**Joint response of Suffolk Coastal District
Council and Suffolk County Council
to
Scottish Power Renewables Phase 4 Public
Consultations
on
East Anglia One North and East Anglia Two
Offshore Wind Farm Projects**

RESPONSE OF SUFFOLK COASTAL DISTRICT COUNCIL AND SUFFOLK COUNTY COUNCIL TO PHASE 4 PUBLIC CONSULTATIONS BY SCOTTISH POWER RENEWABLES ON THE EAST ANGLIA ONE NORTH AND EAST ANGLIA TWO OFFSHORE WIND FARMS.

Figure 1 – Estimated catchment of the Main River through Friston

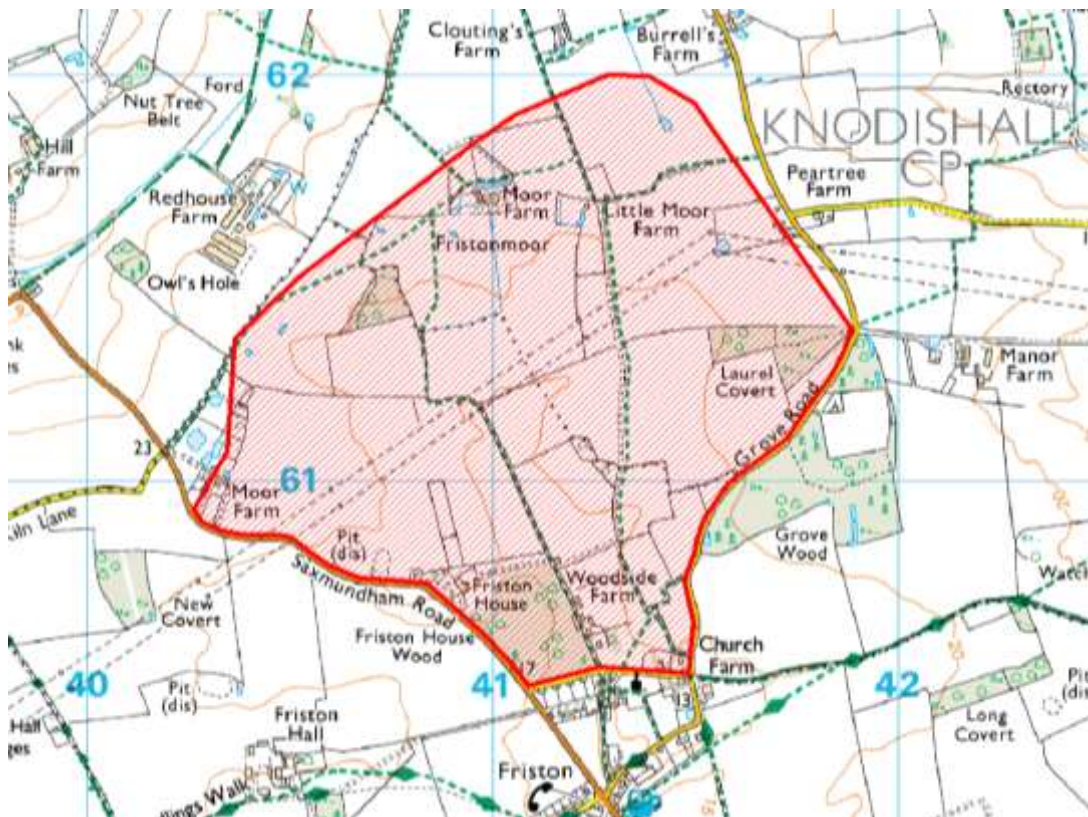
- 1 The catchment contributing to the Main River through Friston is estimated as 1.5km². This is based on the catchment extending to the boundary of the WFD River Catchment Area and being confined by Saxmundham Road and Grove Road. Whilst this is a simplistic approach it is the only one available without access to more accurate information (LiDAR/topographical surveys). This area is shown in red in the below screenshot, Figure 1.

Figure 2 – Sketch over lay of 1:100 & 1:1000 surface water flow paths with proposed SPR substation infrastructure

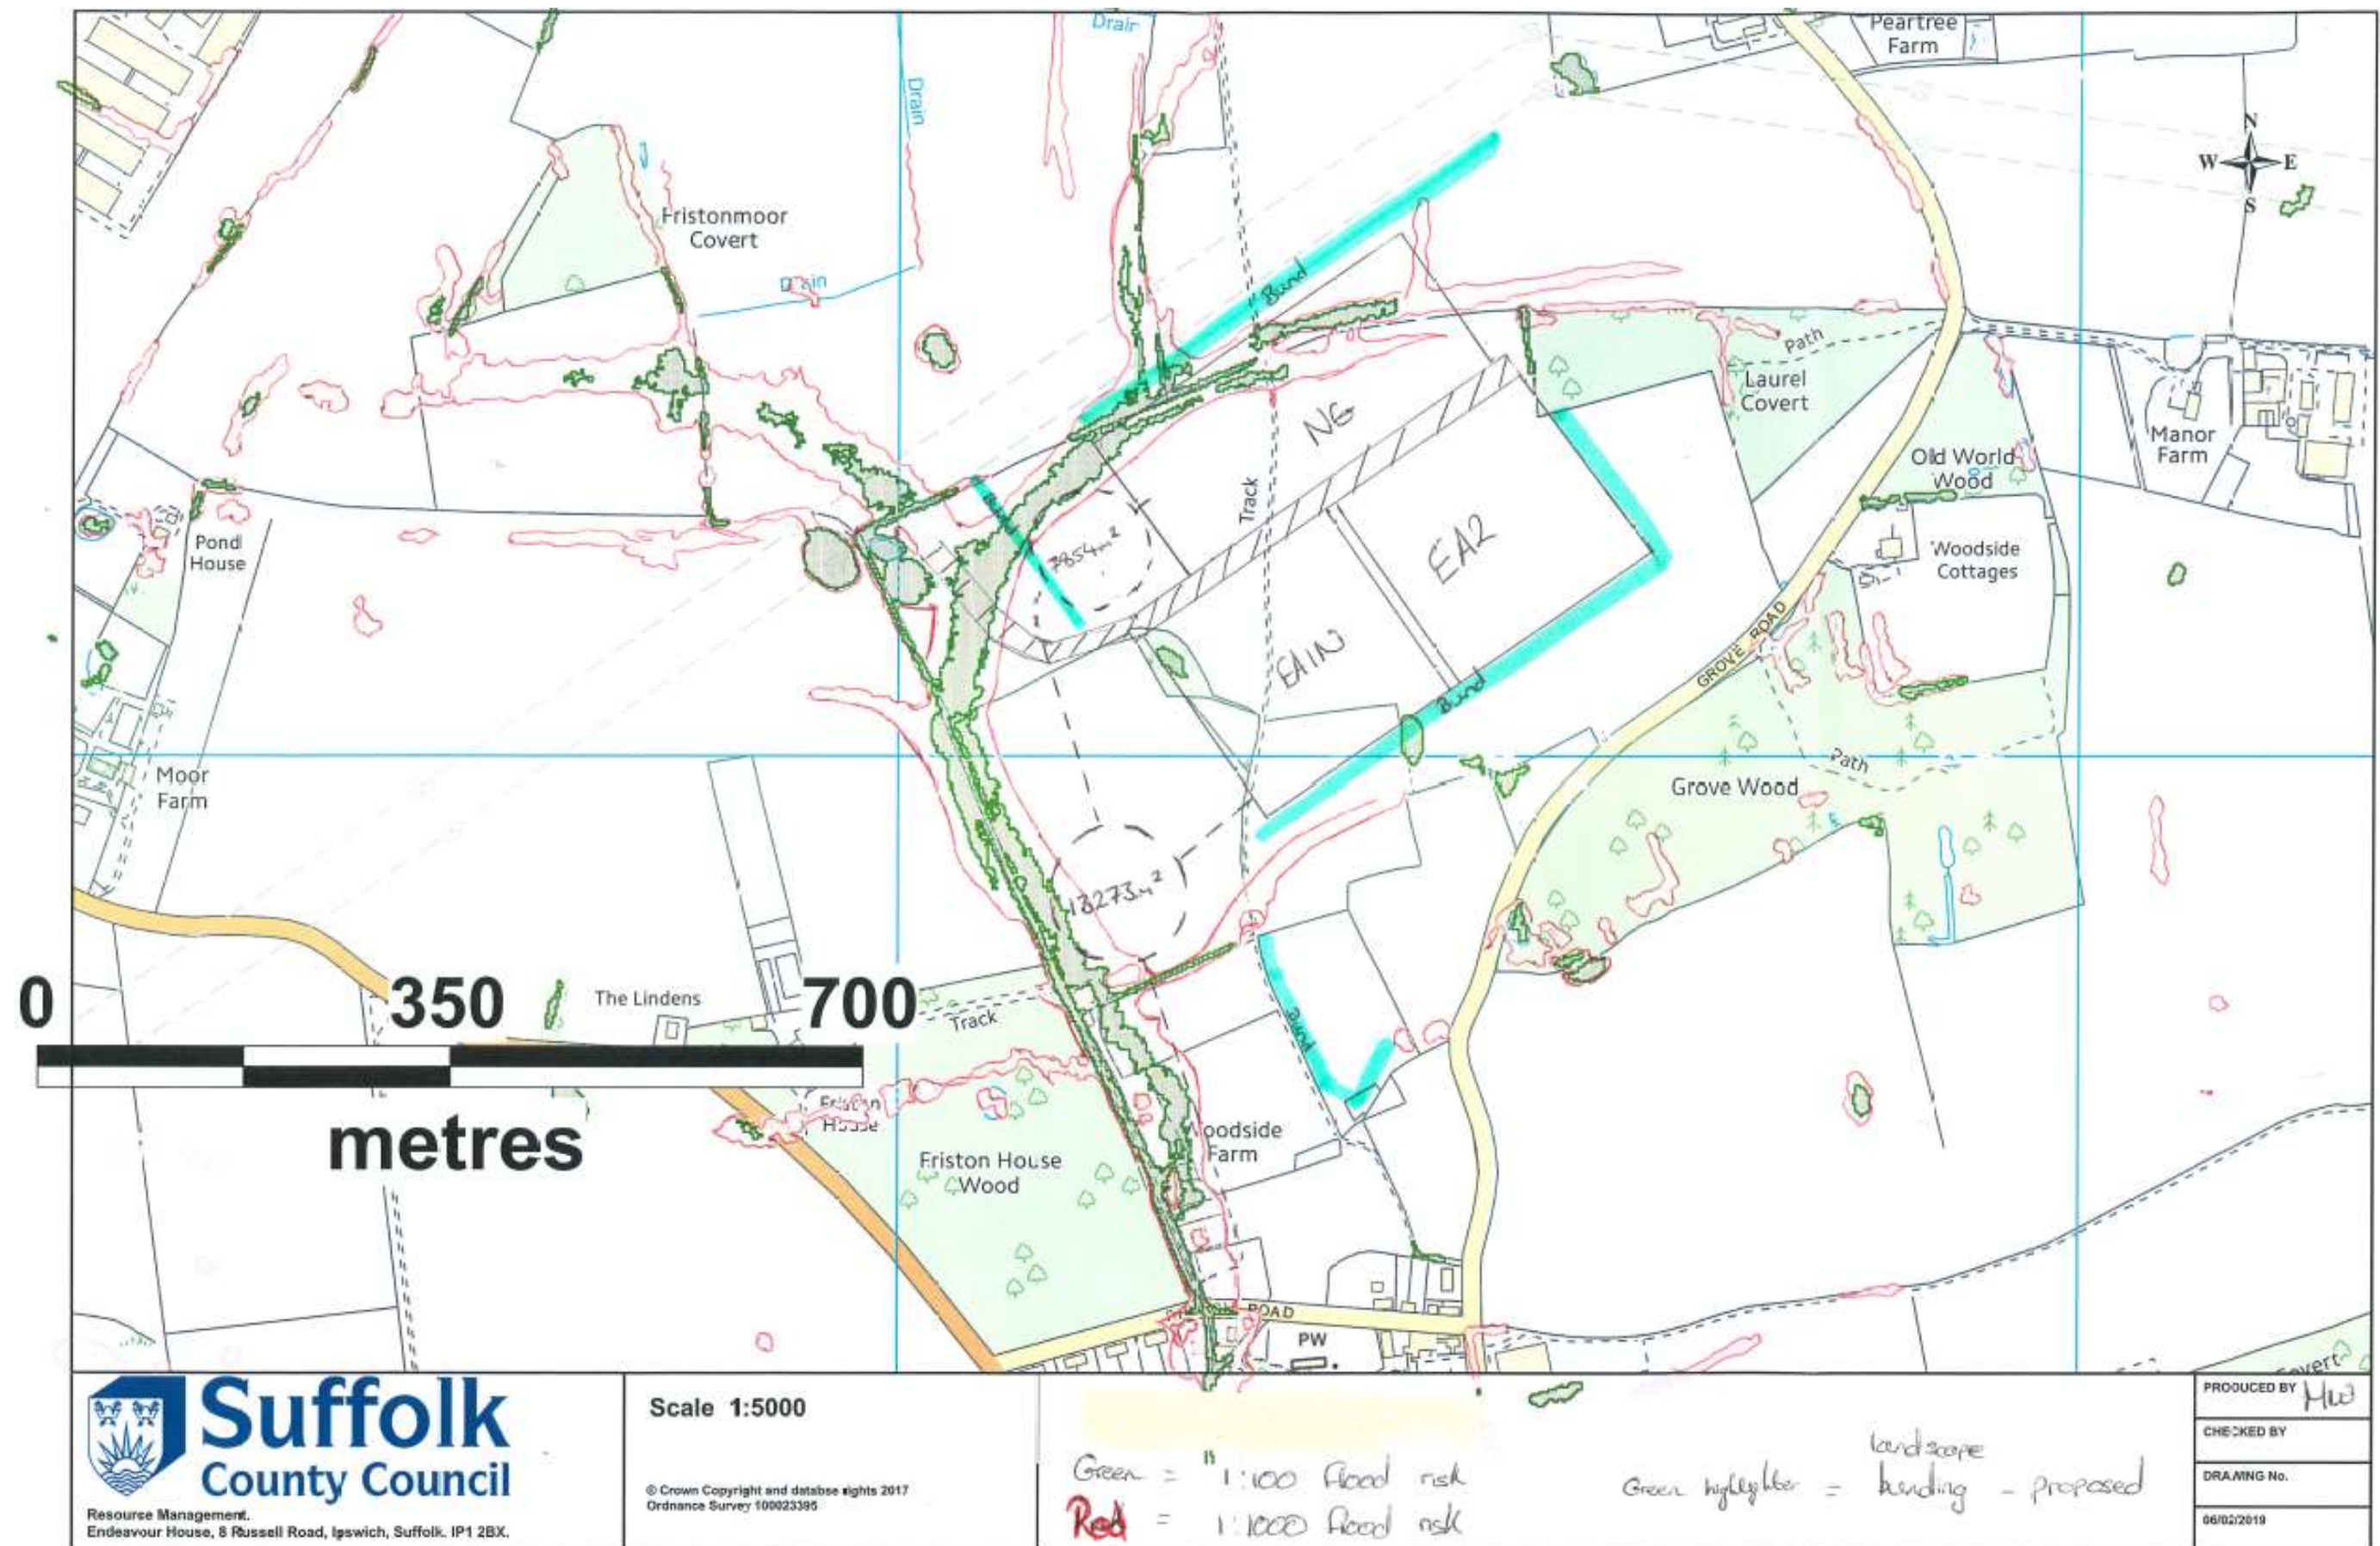
- 17 It should be noted that if both EA1N & EA2 are granted consent, the construction phasing will have a major impact on the area required for SuDS. Simultaneous construction would require a much larger area to be used for SuDS to accommodate the surface water generated by impermeable surfaces. The fact that greater areas of land would be required are not a reason to negate the prioritisation and use of SuDS.

- 18 Overall, whilst the examples given and the indications are positive, the detail regarding embedded mitigation is to be provided at a later stage. It is therefore not possible to comment on its acceptability, or whether it provides sufficient mitigation as part of the PEIRs assessment.
